**NUMBER:** 18-068-16

**SUBJECT:**

MIL Illumination: DTCs P112C and/or P112D

2015 - 2016 (KL) Jeep Cherokee

**Fig. 2 New O2 Sensor**

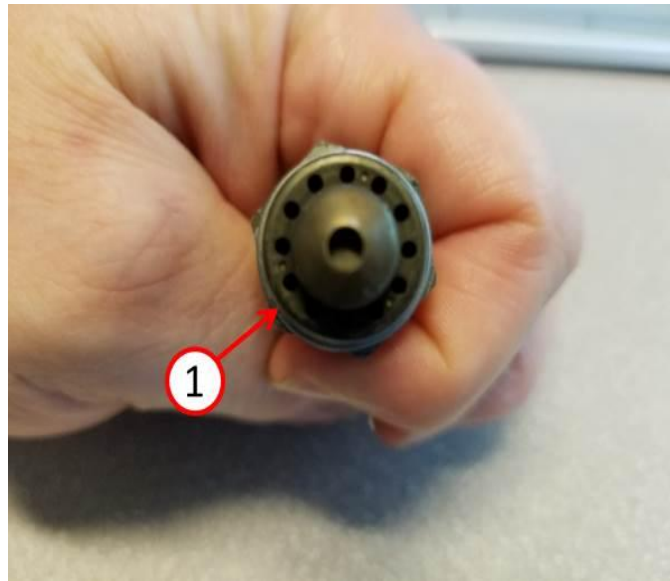
3. Examine oxygen sensor and identify if it is the old design ([Fig. 1](#)) or if it is the new updated design([Fig. 2](#)).

1 - Old sensor (without holes)

1 - New sensor (with holes)

**NOTE: The oxygen sensor should only be replaced with the updated design.**

- 
4. Is the oxygen sensor that was removed the old design?
    - a. YES>>> Install the new updated design oxygen sensor.
    - b. NO>>> This Bulletin does not apply. Normal diagnosis should be performed.
  5. Clear any DTCs that may have been set in any modules.
  6. Lower the vehicle. Refer to the detailed service procedures available in DealerCONNECT> TechCONNECT under: Service Info> 04 - Vehicle Quick Reference> Hoisting> Standard Procedure.
